Reviewer 2

Overview

This paper considers future changes in ‘extreme flow regimes’ in 19 hydrological regions in Switzerland as interpreted from annual flow duration curves and annual hydrographs aggregated as monthly average flows. Two novel methods are applied to generate estimates for the 100-year regimes for the current climate (using simulations driven by observed meteorological data) and a future climate (with simulations driven by bias-adjusted climate model output). The methods are illustrated using four example regions, representing both rainfall-dominated and snowmelt-dominated flow regimes, before being applied to the 19 hydrological regions. The results point towards patterns of change which are distinct for rainfall-dominated vs. snowmelt-dominated flow regimes, and which are consistent with previous work and with changes in the hydrometeorological drivers. The authors also propose that the two approaches applied give similar and consistent results.

Figure 1: Comparison of the 100-year high-flow estimates, univariate, FDC, and stochastic with stochastically generated hydrographs (orange lines). The legend is equivalent to the one provided for Figure A1 in the manuscript.

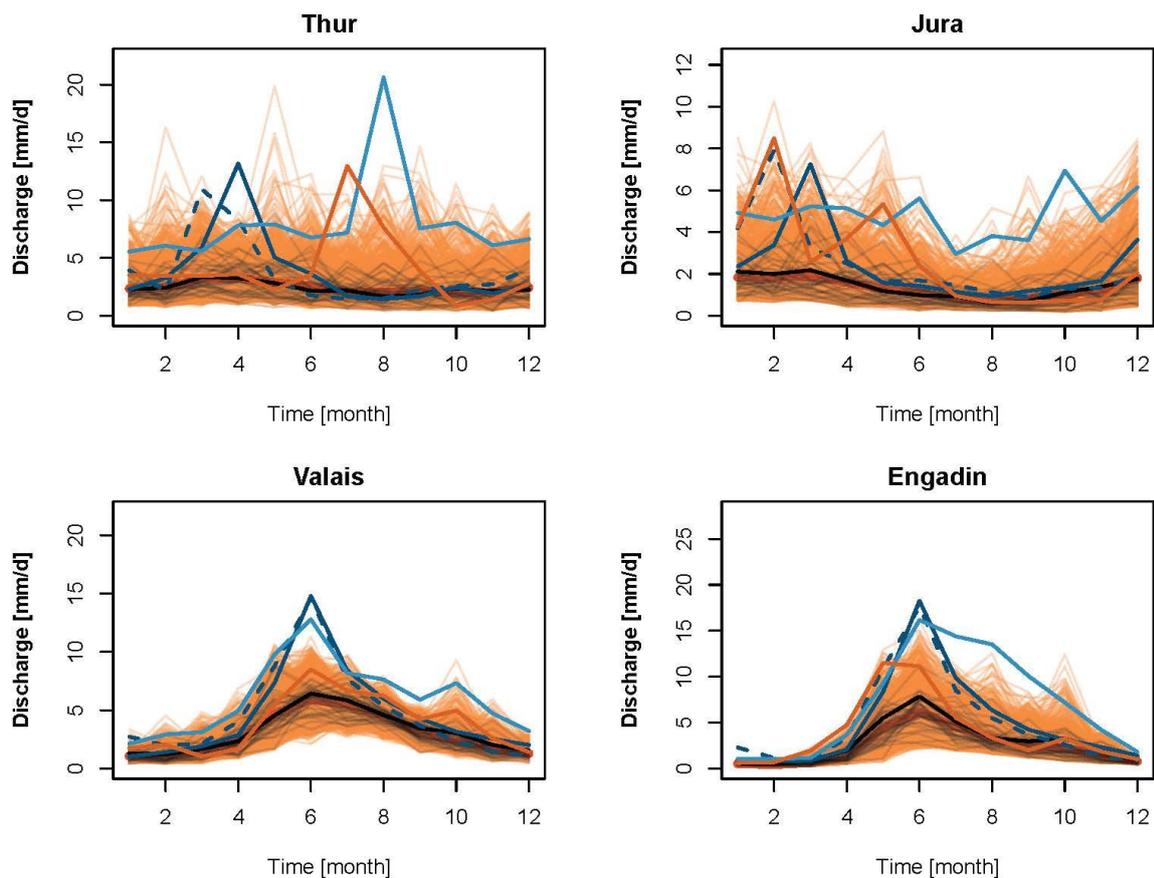
P10 L5-7 Why is the seasonality so variable between the FDC, Stochastic and Univariate estimates in the rainfall-dominated Thur and Jura catchments? Doesn't this undermine the credibility of these methods for considering high flows in these and other rainfall-dominated catchments?

P10 L10-12 Given my comment above, I am also curious as to what Fig. A1 looks like for high-flow regime estimates? In particular, the stochastic results for Jura in Fig. 5 suggest that the method doesn't perform better than the univariate approach in that case.

Reply: *We will specify that the univariate approach produces unrealistic results in terms of seasonality, since the predictions of the monthly 100-year flows neglects the dependence between the different months. The FDC and stochastic approaches produce rather similar results excepts for the Thur catchment. While the FDC approach works with a mean seasonality, the stochastic approach uses the seasonality of one specific realization (annual hydrograph), whose discharge sum corresponds to the 100-year discharge sum.*

Reply: *The stochastic approach is not supposed to exactly reproduce the mean seasonality reflected by the FDC approach. While the seasonality generated by the univariate approach is something completely artificial, the seasonality produced by the stochastic approach could have been observed. Figure A1 was also produced for the high-flow estimates and is provided here for completeness.*
